AGENDA
PLANNING AND ZONING COMMISSION WORK SESSION
City Hall, 385 South Goliad, Rockwall, Texas
Council Chambers
January 2, 2019
6:00 P.M.

PLANNING AND ZONING COMMISSION MEMO

PLANNING COMMENTS - DAVID GONZALES - 12.18.2018

2 BUILDING ELEVATION
SCALE: 1/16" = 1'-0"

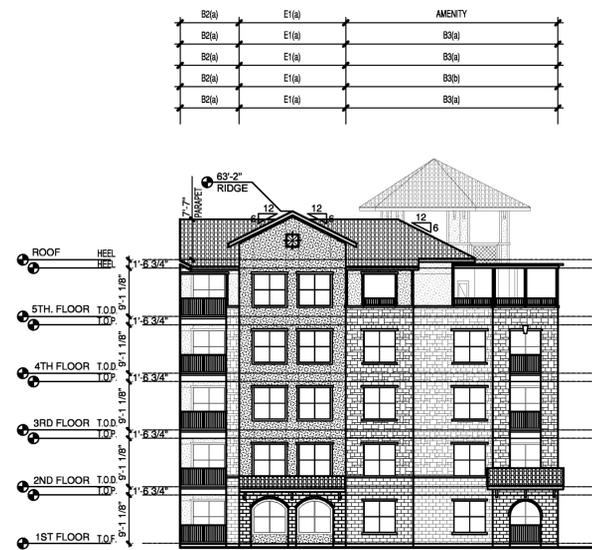
- a. Sheet A4-10 - elevation no. 2 = 19% [elevation faces the pedestrian walkway]
 - b. Sheet A4-11 - elevation no. 5 = 16% [elevation faces commercial properties to south]
